# Building Permit Application

Permit No.: B15001403

**From:** Oswald, Hank  
**Sent:** Wednesday, April 29, 2015 11:00 AM  
**To:** 'CHRIS@CTCONTRACTINGINC.COM'  
**Subject:** B15001403\_13505 Mitchells Way

**Carlson Poolhouse**  
PROPOSED POOLHOUSE  
13505 Mitchells Way, West Friendship, Maryland 21794

ON-SITE SEWAGE DISPOSAL SYSTEM  
 HOWARD COUNTY HEALTH DEPARTMENT  
 BUREAU OF ENVIRONMENTAL HEALTH

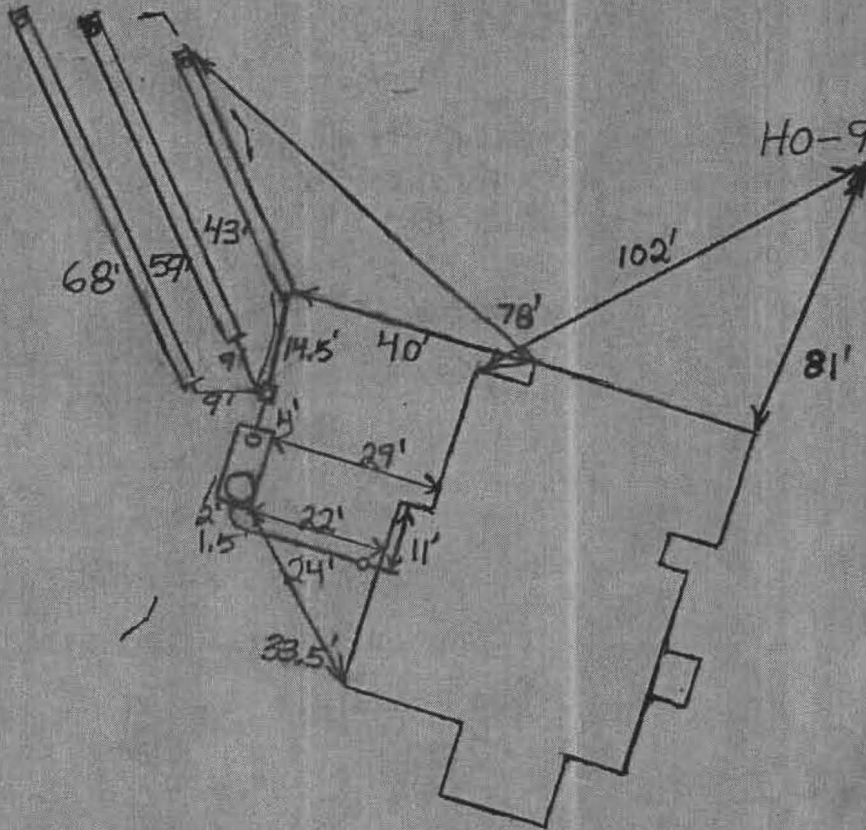
6/28/2011 Specs. changed to save easement area. Install three trenches on contour across the highest part of the septic easement. O.K. to set the tank partially in the easement area. Set the tank near where shown on the B.P. plan. (BA)

6/30/2011 System finished. O.K. to backfill. (BB)

FLOOR PLANS

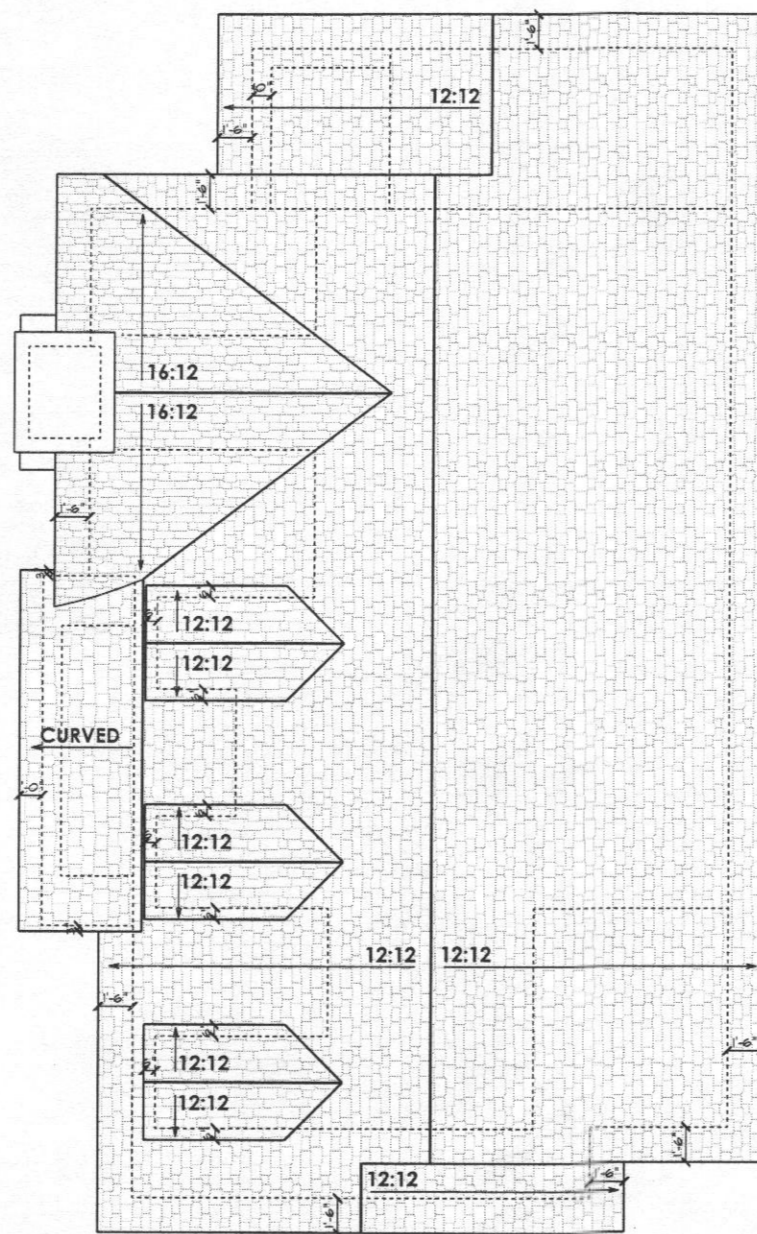
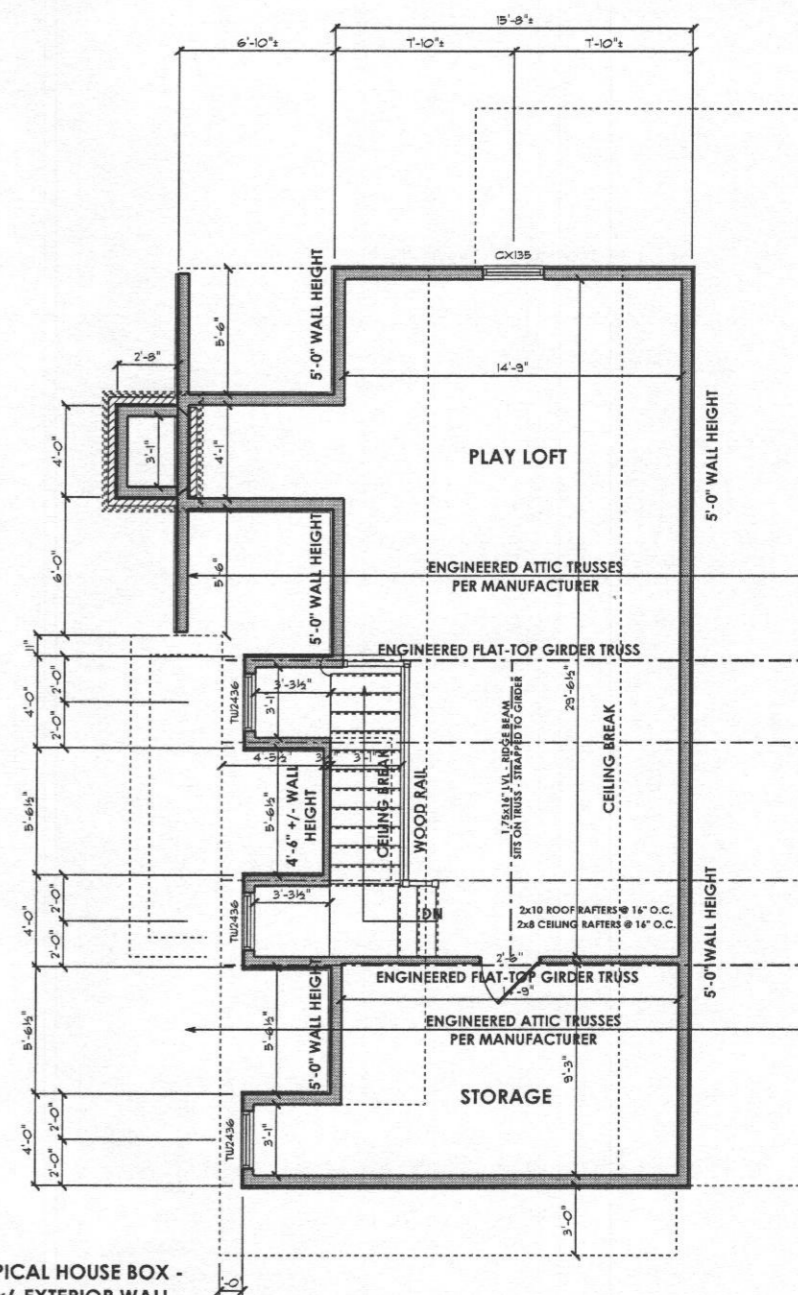
> Just to confirm, the pool house will not have plumbing?

This letter is in response to building permit B15001403. The application describes 1-1/2-STORY DETACHED POOLHOUSE W/1-CAR GARAGE. Upon review the submittal, the building permit did not include a copy of the floor plans for the pool house and garage.

Building permit approval is being placed on hold until floor plans have been forwarded to the Health Department for review. I may be reached at (410) 313-1786, if you would like to discuss the project.

Correct. No plumbing
